SECTION 00 91 13
ADDENDA

ADDENDUM:	<u>No. 2</u>
ADDENDUM DATE:	<u>August 26, 2024</u>
BID DATE:	<u>August 29, 2024</u>

This **ADDENDUM** is issued to institute the included changes and/or deletions to the Plans and Specifications for the **IFB# 026-45 HALL COUNTY-SPOUT SPRINGS WATER RECLAMATION FACILITY EXPANSION TO 1.6 MGD** project and hereby becomes a part of said Plans and Specifications.

SPOUT SPRINGS WRF
ADDENDUM 2
EXHIBIT 1-SBR BLOWER
PIPING

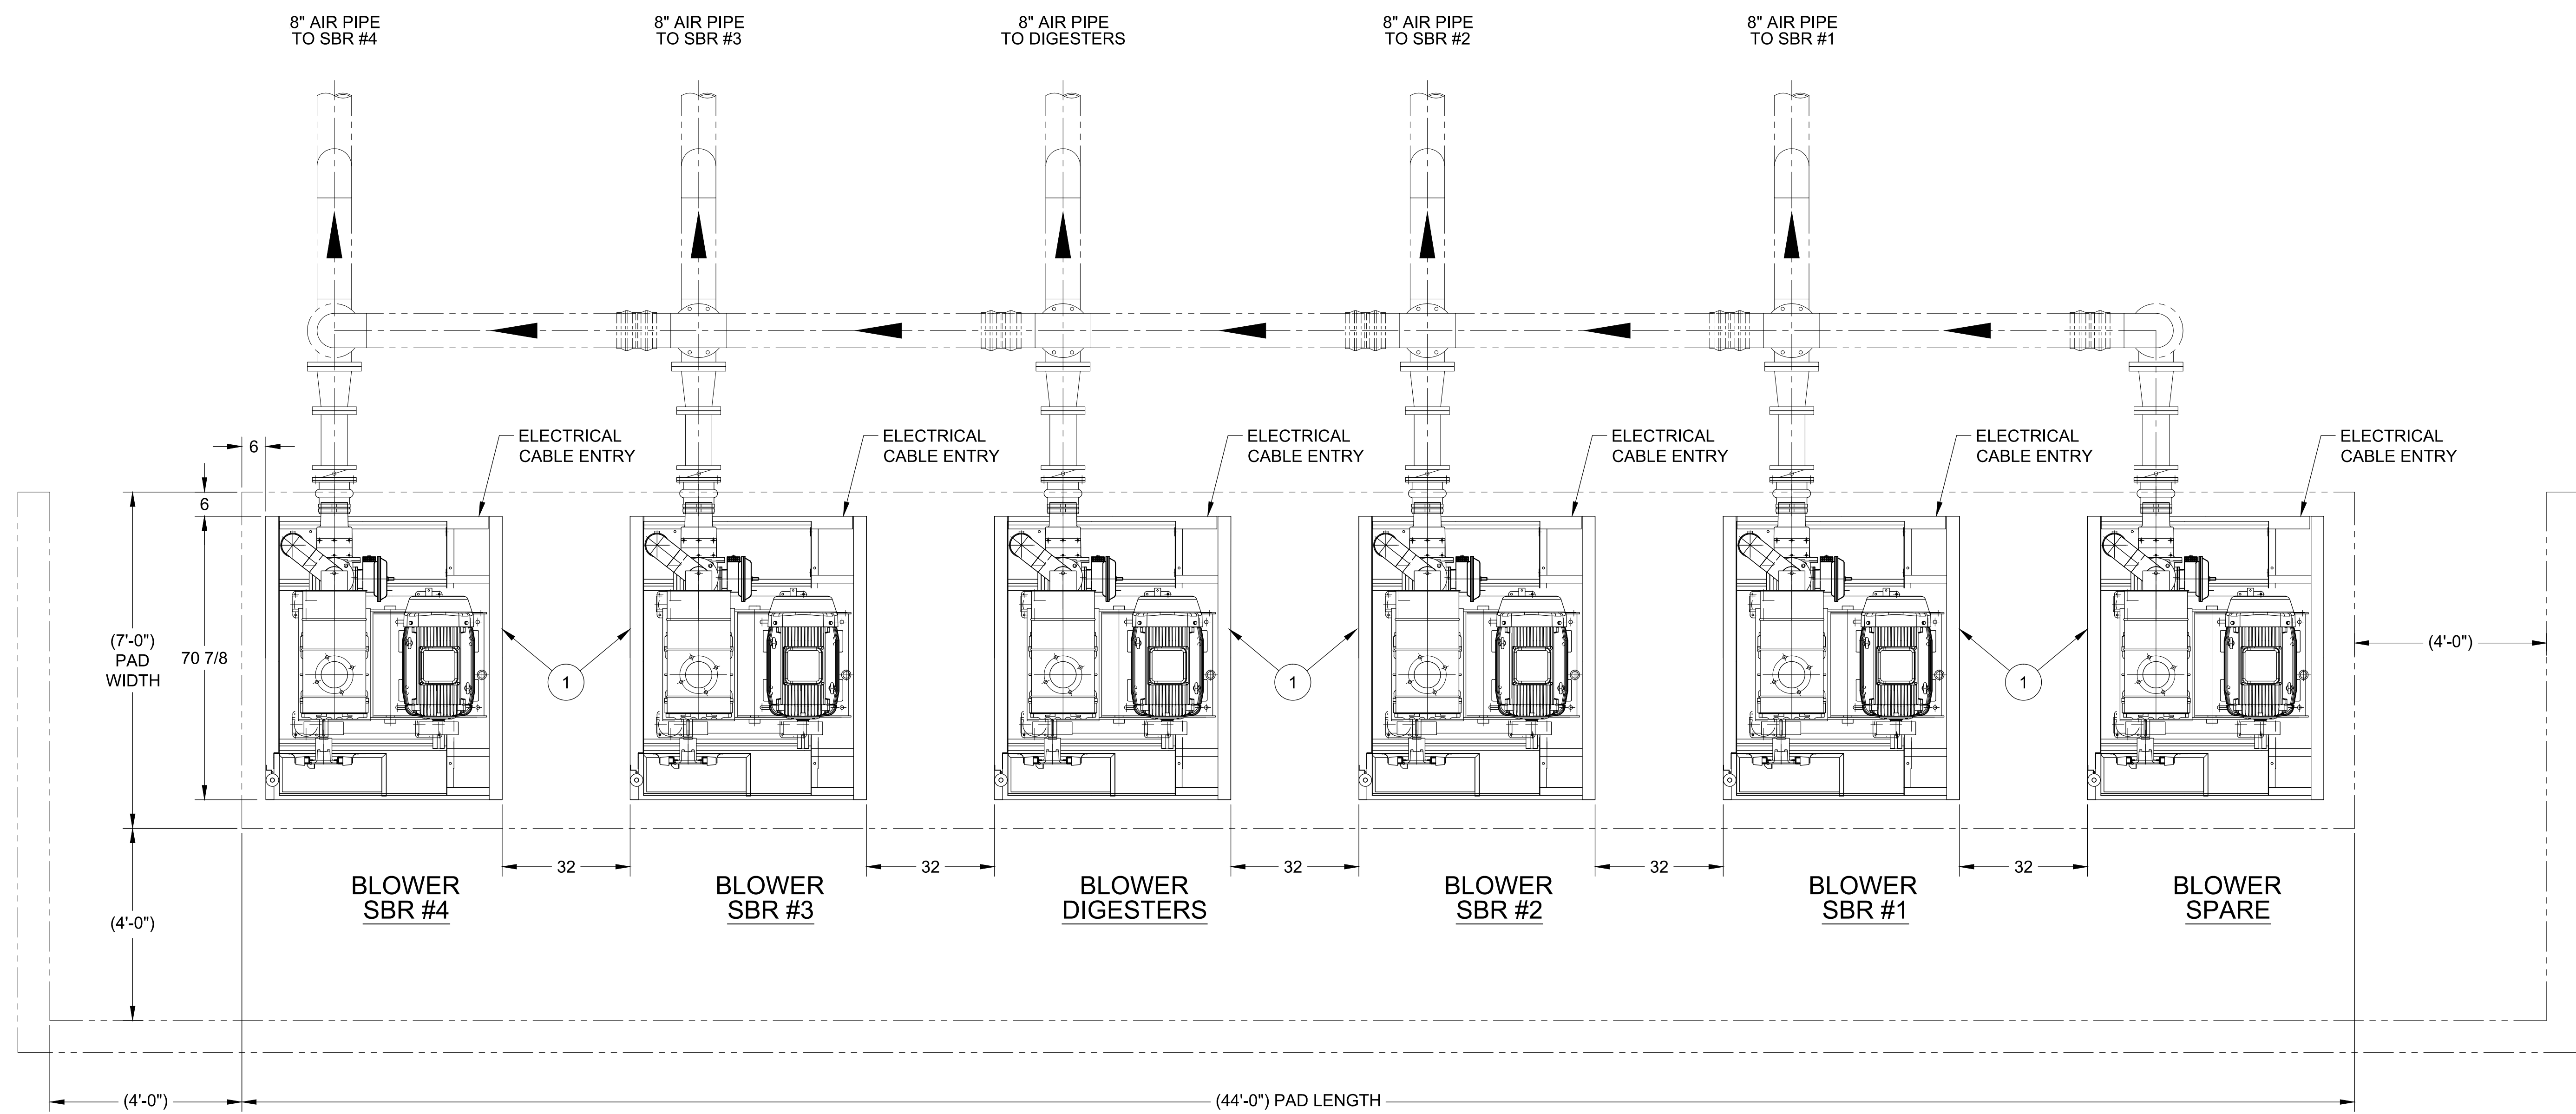
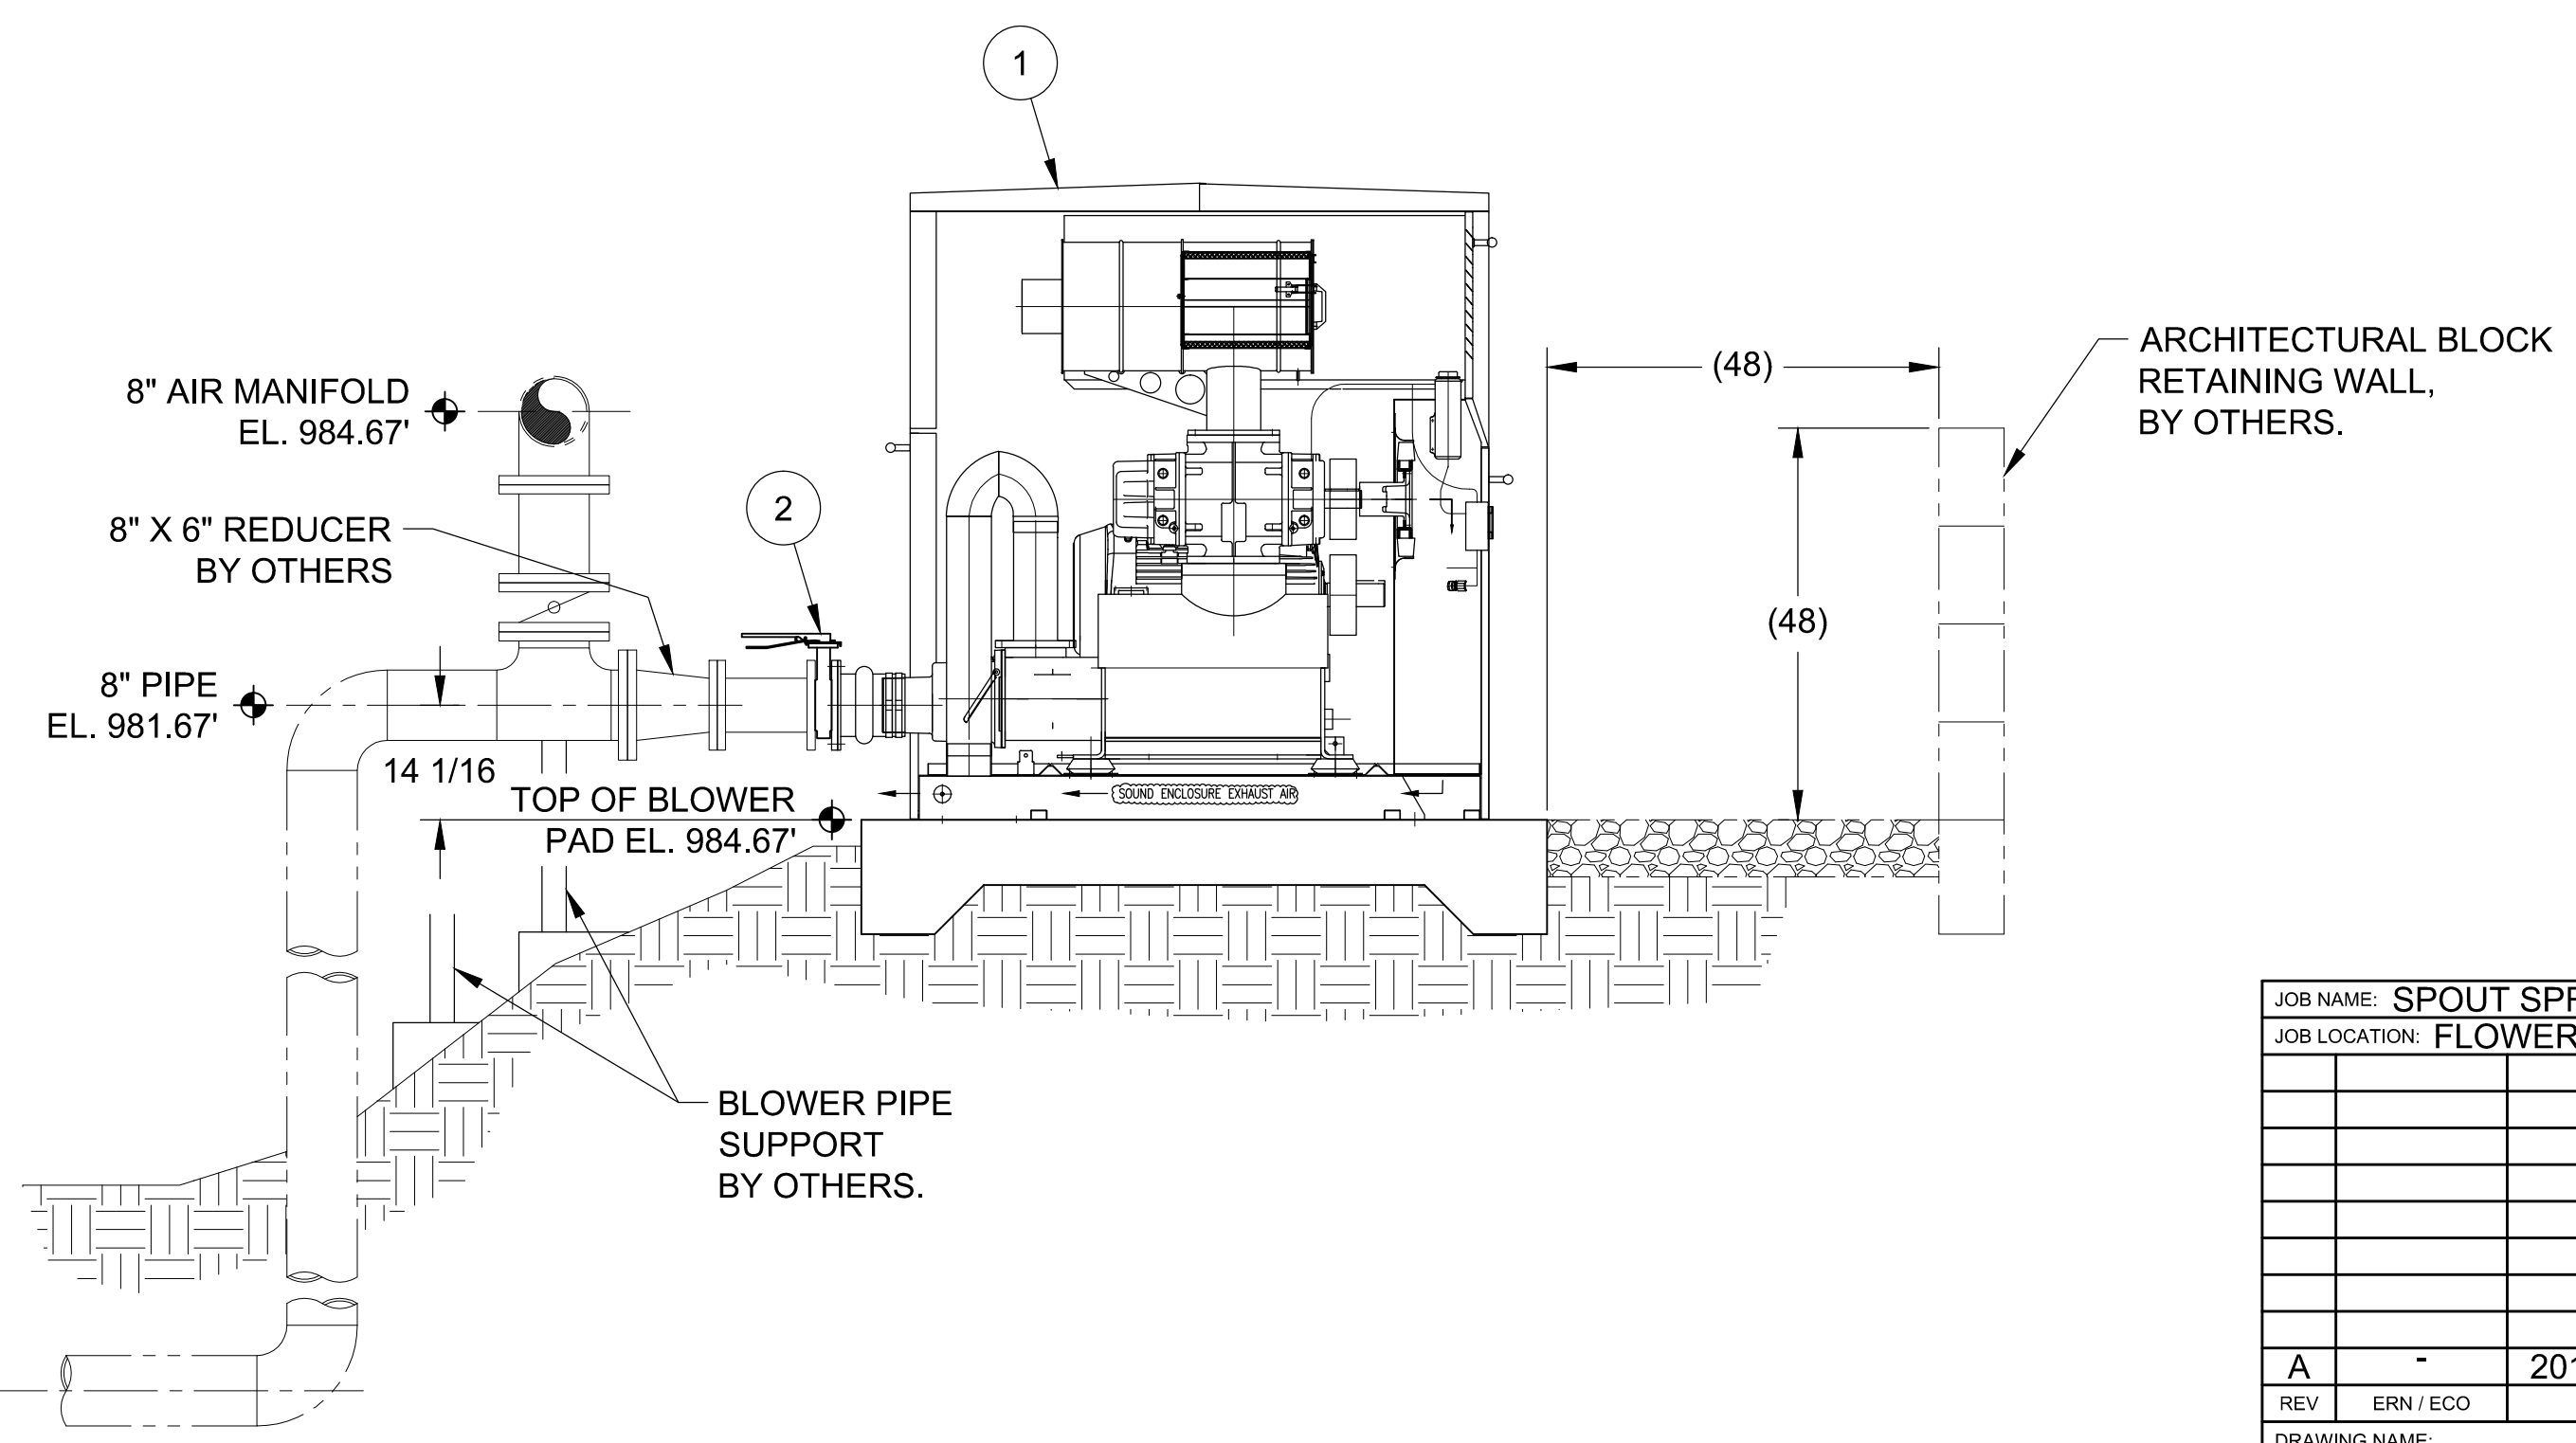
33. Drawing 7-M-3 and 7-M-8 show 8" SS Air Piping coming up out of the ground but with no section views, pipe elevations, or other details. Notes 2 & 3 on 7-M-7 state Aqua Aerobics will design the proposed air piping layout (after the bid, since it is not included with the bid). Aqua Aerobics is the pre-selected/sole sourced equipment provider for this system, so it seems most appropriate for the design of the piping system to be completed prior to bid. Note that the Aqua Aerobics scope included in Appendix A does not include any design. Does the additional design scope need to be negotiated with Aqua Aerobics by the Contractor in their bid, or will the Owner handle this? Please provide additional information on the air piping in the basin for contractors to base their bid on.

The Contractor is to core the exterior SBR No. 4 basin wall for proposed air piping. Install proposed air piping with link seal and grout fill gap on both faces. Contractor to provide schedule 10S air piping riser with 90-degree bend, stainless steel spool with weld neck flange and flanged metal bellows expansion joint to match the pipe size.
